DOCUMENT 009113 – ADDENDUM FIVE

- A. Project Name: Small Craft Harbor Pedestrian Overpass, Biloxi, Mississippi
- B. Project Location:
- C. Owner: City of Biloxi
- D. Architect Project Number: 17069
- E. Date of Addendum Five: August 3, 2018

1 Plan Detail - Corner Detail at Elevator
3" = 1'-0"

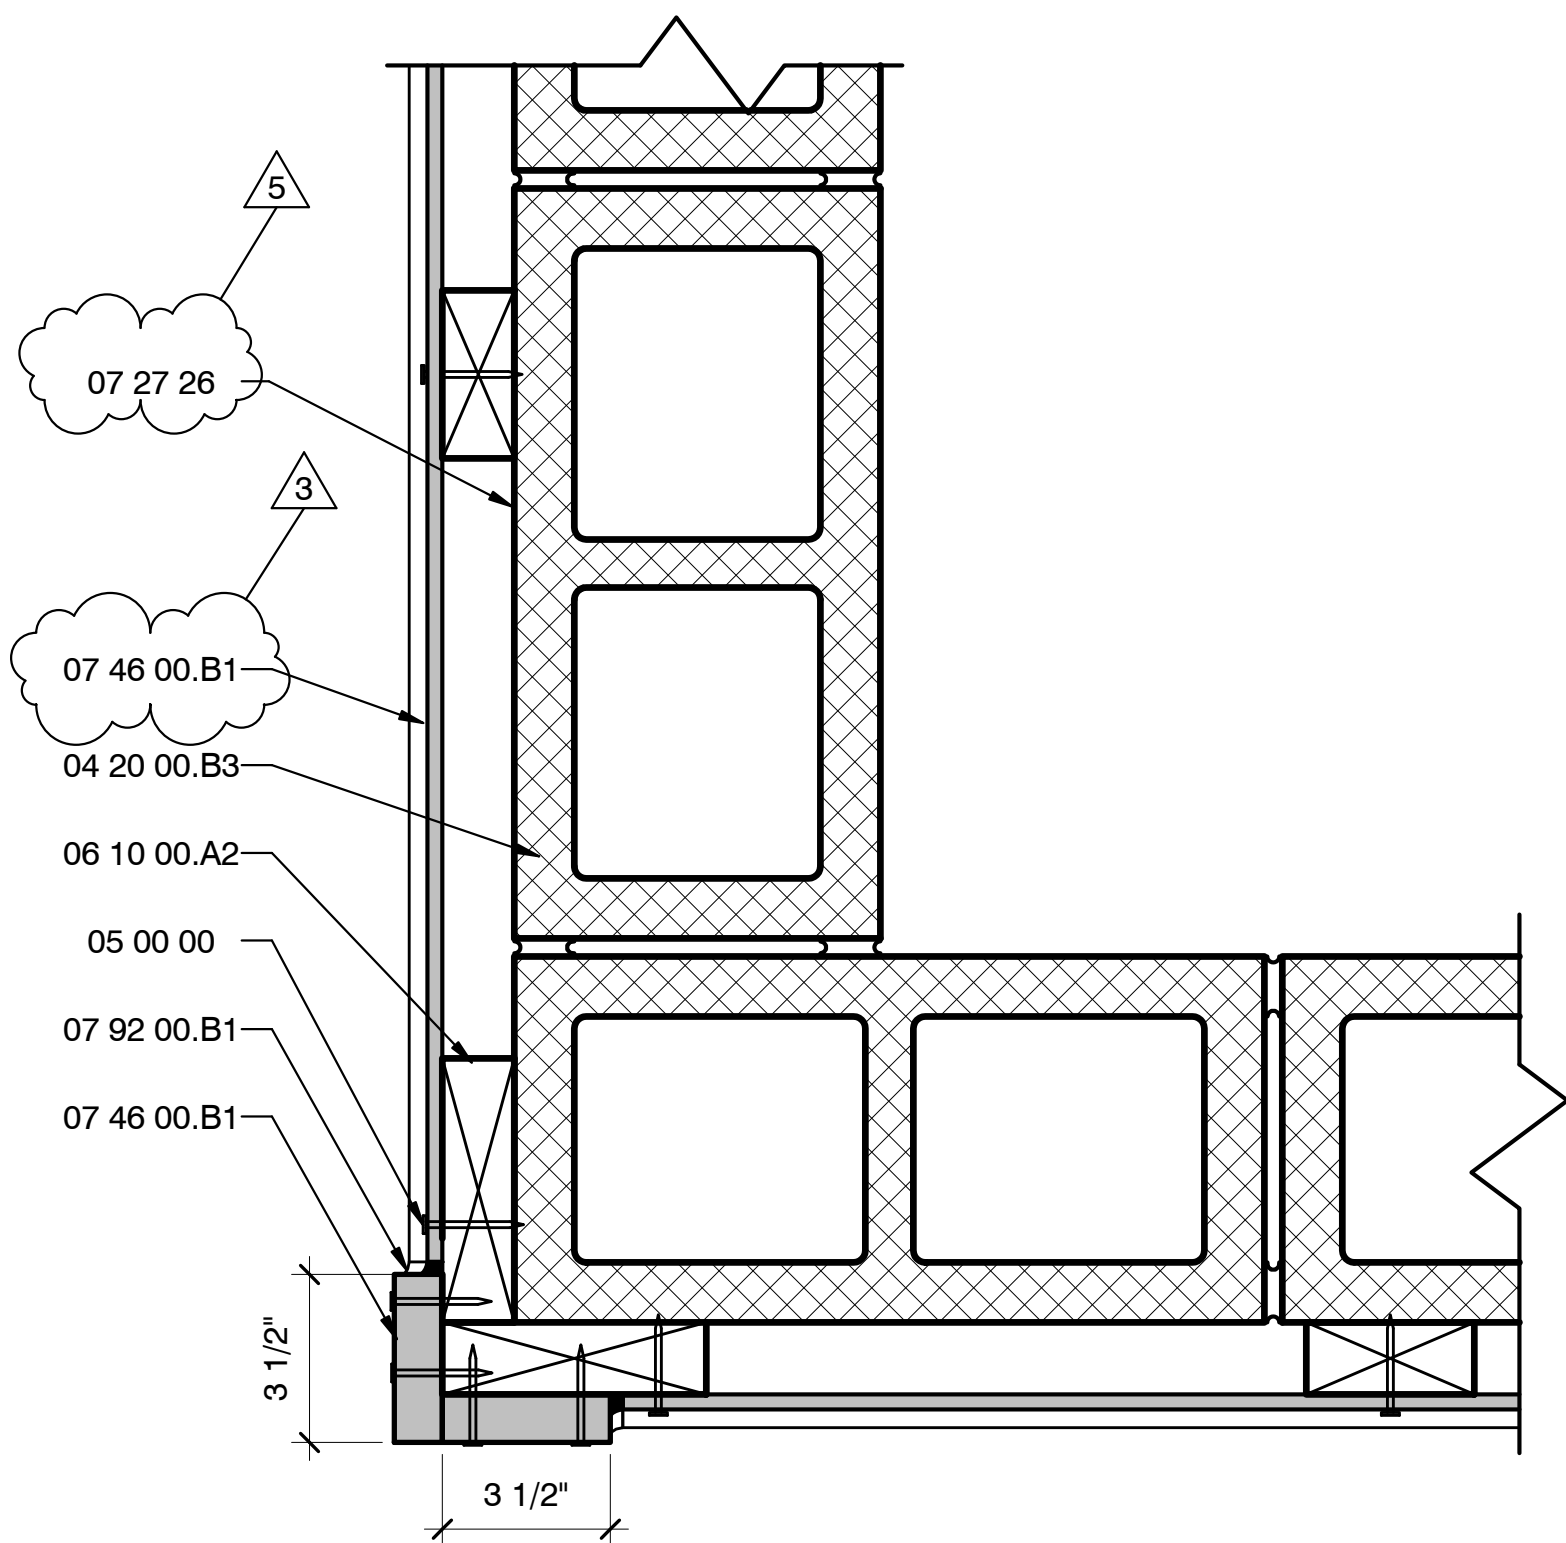
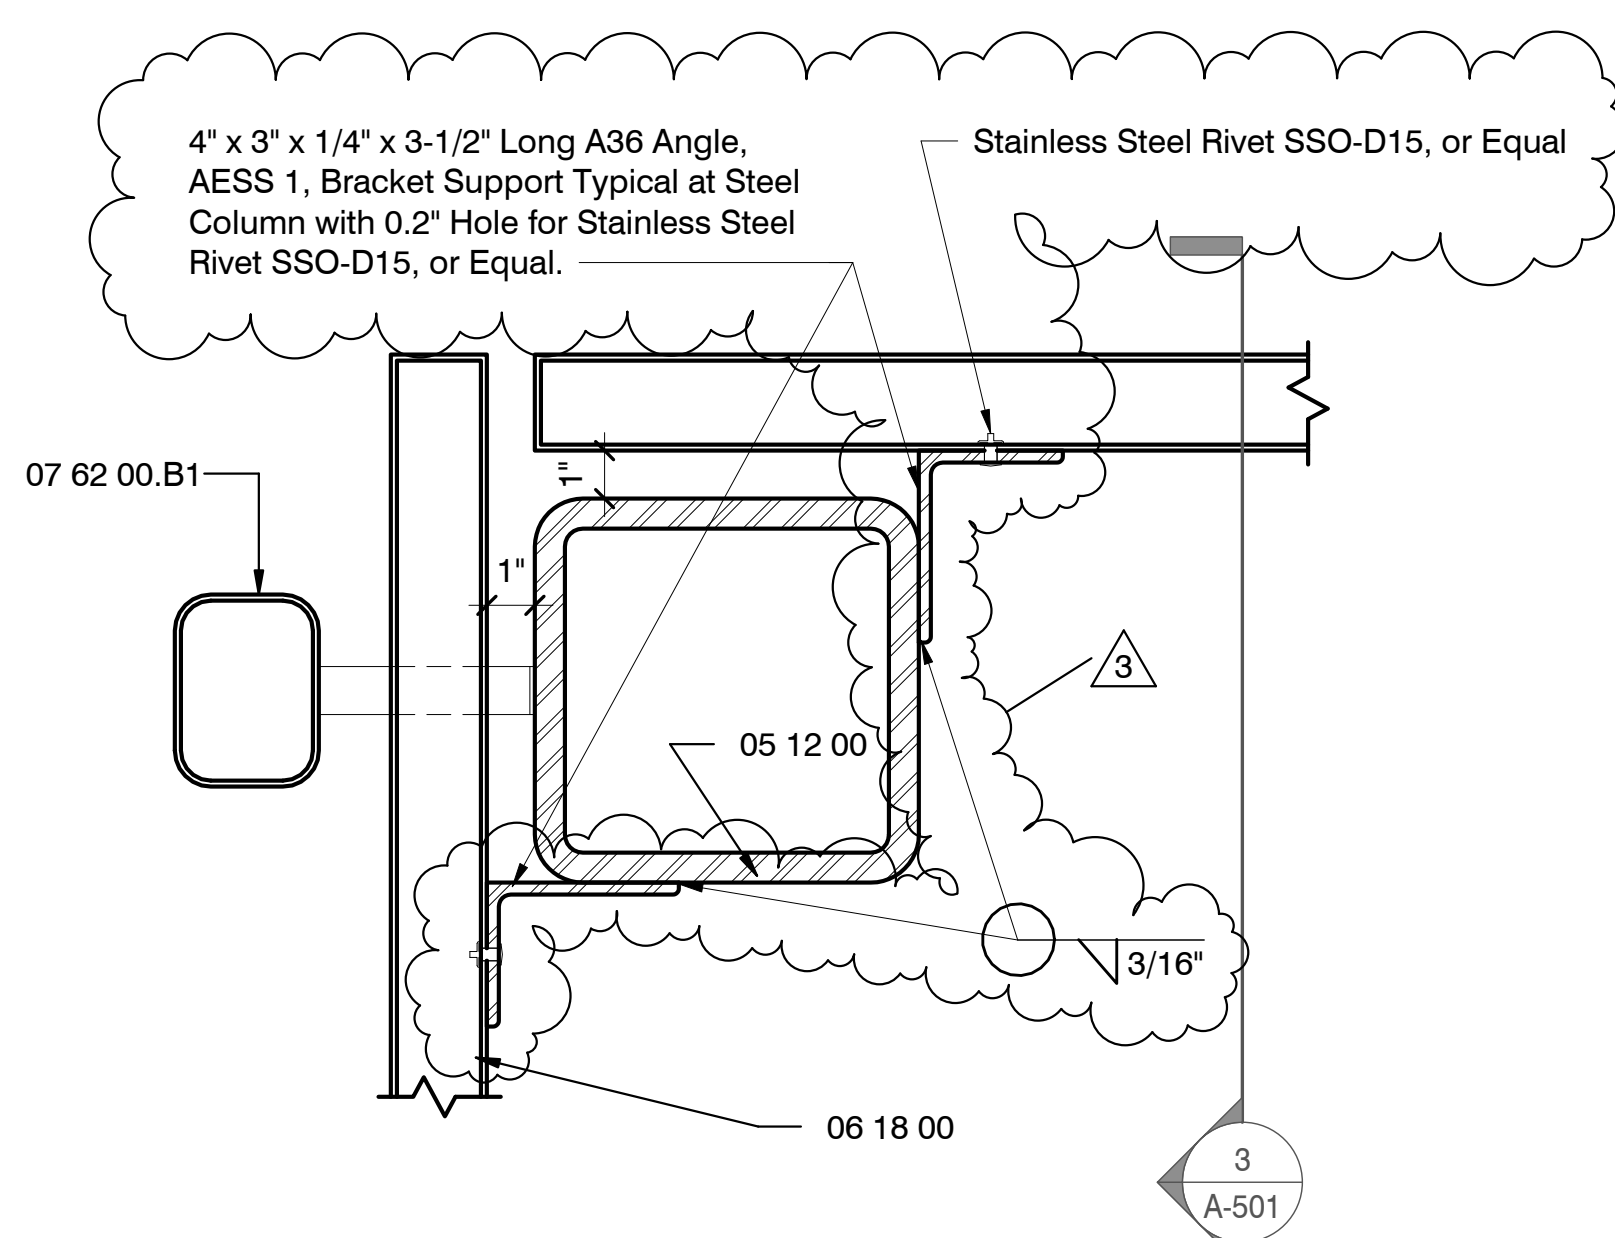
- E. QUESTION: The drawings do not indicate waterproofing on the CMU walls. Is the fluid-applied membrane air barrier system or block sealer to be applied in these locations?

1. New specification section. Please add this to the project manual.
- 1.7 REVISIONS TO DRAWING SHEETS
- A. Architectural Drawing A-501- Exterior Details, (Re-Issued): Fluid-Applied Membrane added.

ANSWER: Fluid-Applied Membrane shown in Re-issued Architectural Drawing A-501 and Issued Specification Section 072726 both by Addendum.
